DC/20/3284/FUL & DC/20/3362/FUL, Chapel Field,
Land to the West of Chapel Road, Grundisburgh

GRUNDISBURGH & CULPHO PARISH COUNCIL'S RESPONSE

March
2021

CHAPEL FIELD
GRUNDISBURGH -
REVIEW OF REVISED
ACCESS PROPOSALS
March 2021

Fig.2 Map of Grundisburgh from 1905; Chapel Field highlighted in red

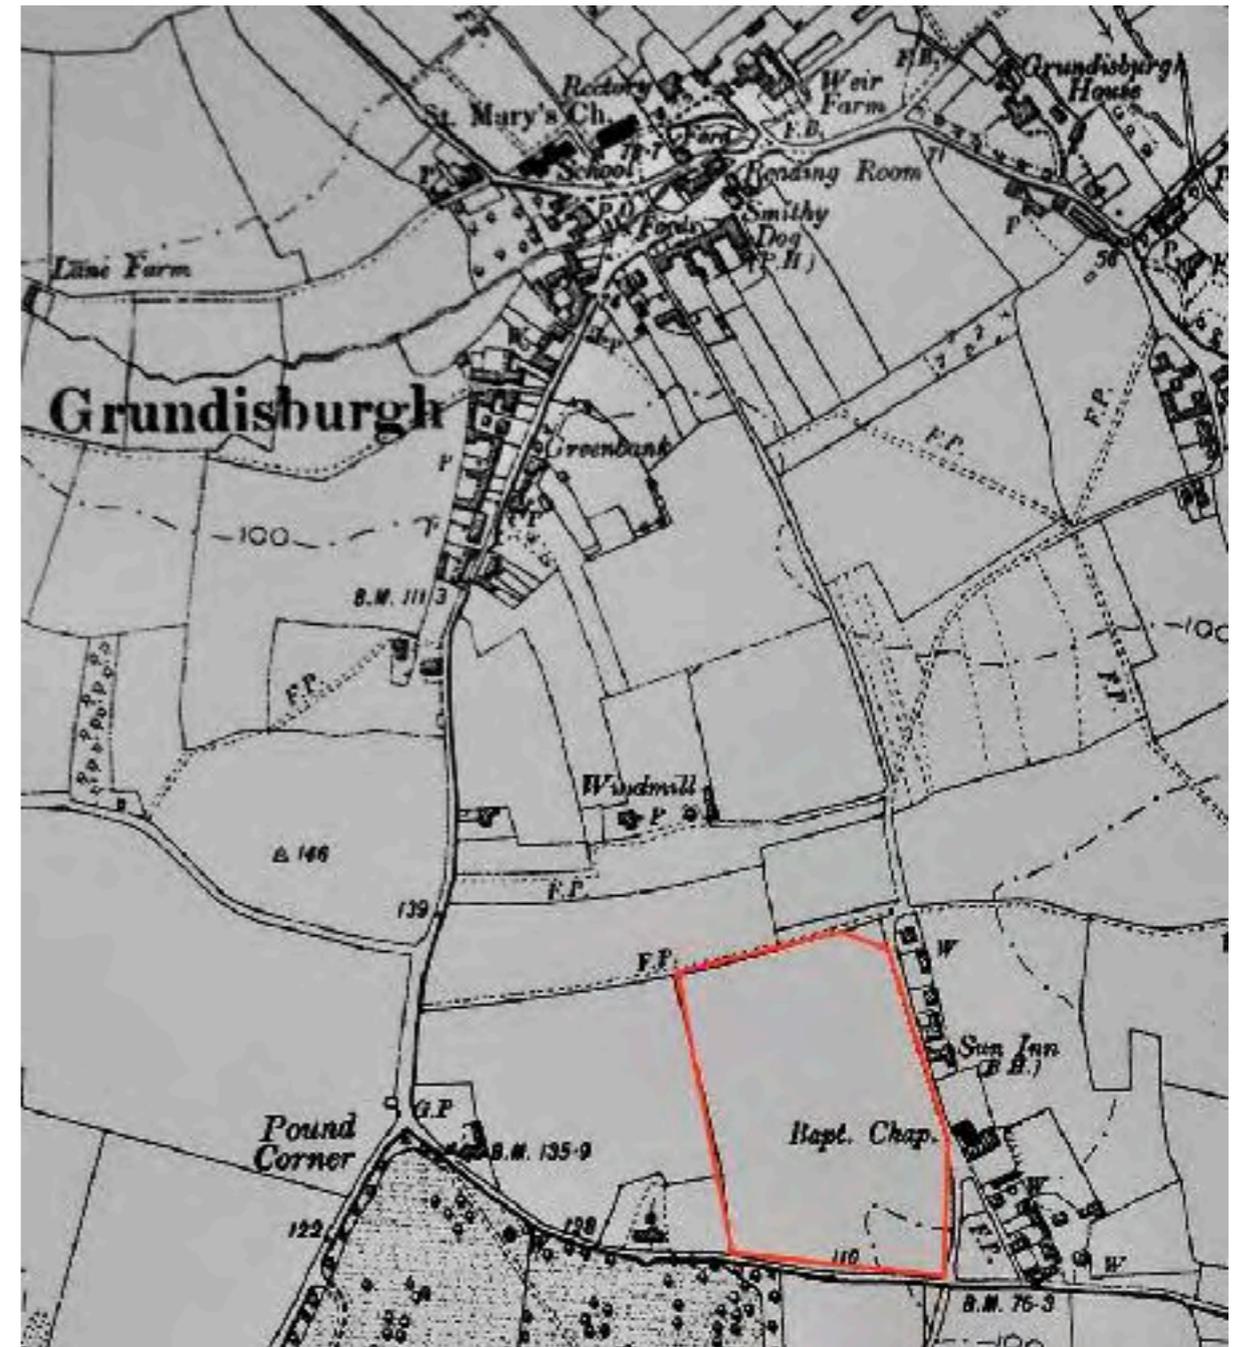
In trying to understand the landscape character of Chapel Field, Aspect would have you look *inwards* to the village for its context and setting but this is **not** how we see it locally.

Although the neighbouring Post Mill and Alice Driver developments provide comfortable homes and welcoming communities, no-one believes that in their layout and design they represent the historic character of Grundisburgh, nor do they think it is fair to use their presence as justification for further vast expansions into the countryside.

Fig.5 View down Park Road onto southern boundary of Chapel Field

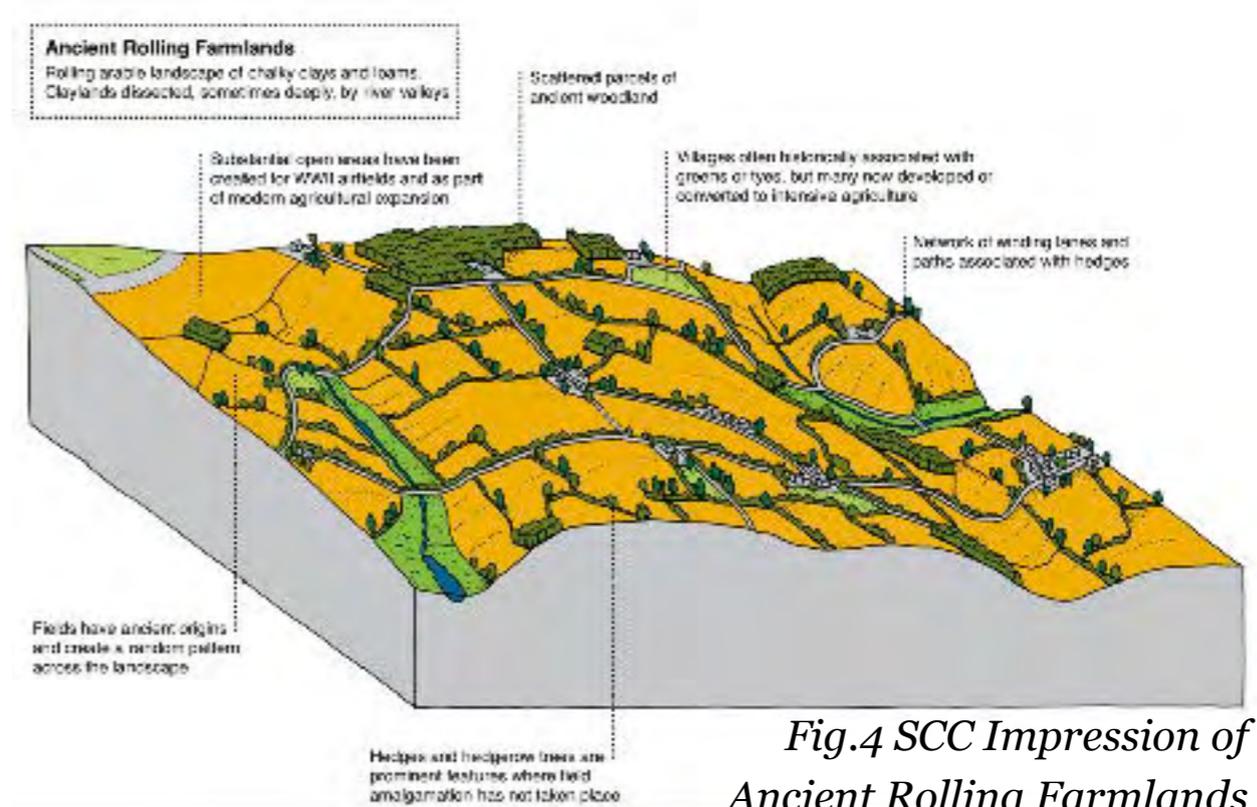
As is demonstrated in the images included in this response, Chapel Field typifies this landscape type and, but not for its proximity to the current village edge, would have proven much more difficult for Aspect to disparage as an ‘urbanised’, ‘low value landscape’. The enclosed ‘intimate’ areas are actually a characteristic feature for the area which planning policy indicates should be protected rather than exploited.

Other landscapes might offer more drama, scale and even tranquility, they are also more remote. Due to Chapel Field’s proximity, accessibility and distinctive setting (being overlooked by an historic place of worship) many more people observe and cherish this landscape on a daily basis than other, arguably more striking, locations. Indeed, from most of the houses along Chapel Road, successive residents have been enjoying this very landscape for over two hundred years in much the same form as now.
